DATE: 06.26.2017
TO: ProTrak
FROM: Bill McDow
 Transportation Planning

■ **PINE VALLE LIBRARY [TRC Plan Review]**

↻ Initial Review Note ↻

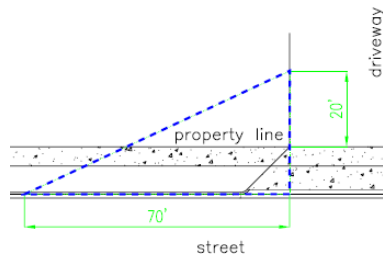
1. Driveways for lots along major thoroughfares must at least 75’ offset from property lines to the curb line. As this driveway has been located as far south as possible, a variance may not be required for the site if other conditions support this location.
